**MPLAB® PM3 ICSP MCLR/VPP Slew Rate Modification**

Figure 1

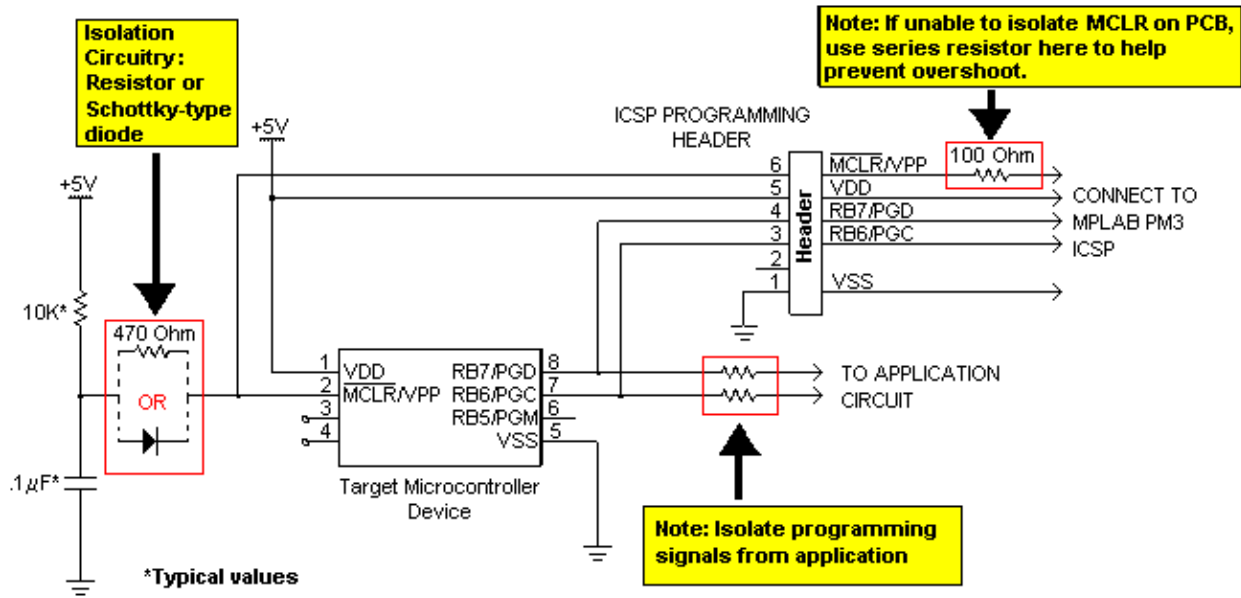
**Symptom:** MPLAB PM3, Assy# 10-00359-R9 or below without ECO 2937, may cause excessive voltage overshoot in applications with a capacitive load that has not been isolated from the MCLR/VPP pin of the PICmicro being used in ICSP mode. Depending upon the size of the capacitive load, this overshoot could cause excessive part stress as well as damage in some cases.

**Problem:** The rise time of the MPLAB PM3 high voltage VPP driver into a capacitive load, causes the voltage at the target microcontroller’s MCLR/VPP pin to exceed the maximum specified voltage.

**Solution:** A 100 Ohm series resistor may be placed between the MPLAB PM3 Device Programmer’s ICSP port MCLR/VPP line and the target’s MCLR/VPP line. See Figure 1 for details. If further problems exist, verify all programming signals meet the target microcontroller’s programming specification.
